SLR Consulting Australia Pty Ltd  
Review of Hydrogeological Report  
Factual Report

April 2020

This report formally documents the independent review, completed by GHD, and subsequent amendments of the Hydrogeological Report on the Water Balance Model, completed in April 2017 by Tetra Tech, for the Mt. Todd Gold Mine.

**Figure 4-3: Mean Monthly Rainfall at Project Site and Katherine Area, 1993 to 2017**

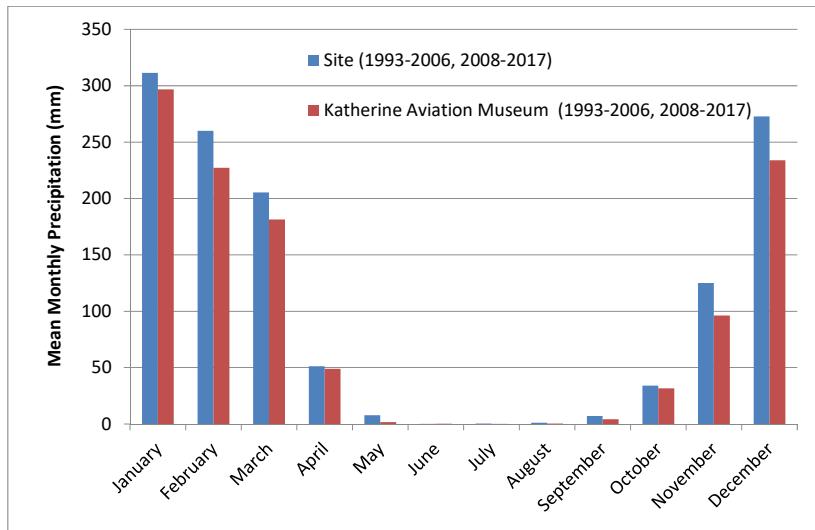
Commented [TM30]: Need to confirm this figure

Commented [TK34R33]: Yes, the values are for different time frames. CLARIFY IN REPORT.

Commented [CS35R33]: See added text noting the dates to which the values apply.

**Figure 5-6: Measured vs. Simulated Hydraulic Head Data**

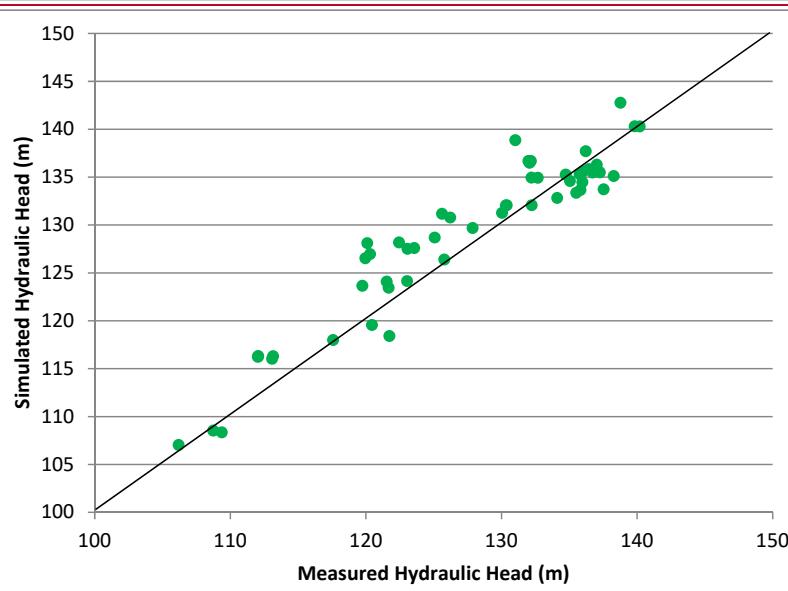
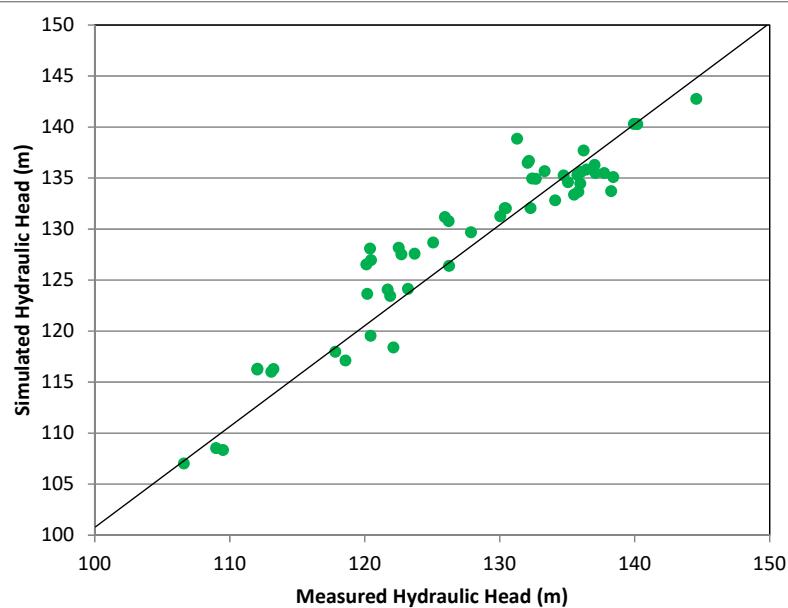
**Commented [TM142]:** The model does meet the criteria to indicate acceptable calibration, but as the calibration statistics have increased from those produced by the original model calibration indicates model parameters may require adjustment

**Commented [TK143R142]:** The model meets acceptable calibration criteria. No further adjustment is required.

Figure 6-5: Predicted Batman Pit Lake Water Balance

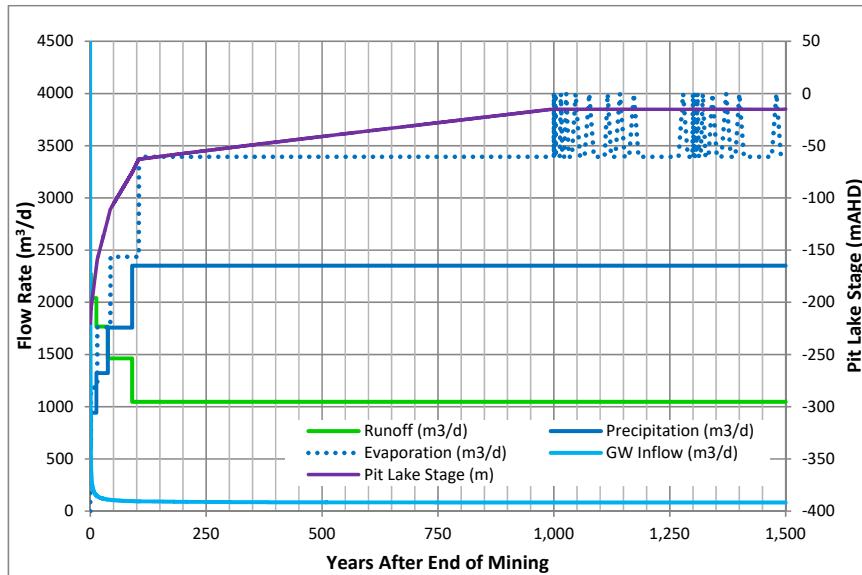
**Commented [TM218]:** Looking at the graph in figure 6-5, it appears that steady state occurs after approximately 1000 years

**Commented [TM221]:** This appears to begin at approximately at 1000 years.

**Commented [CS222R221]:** Agreed.
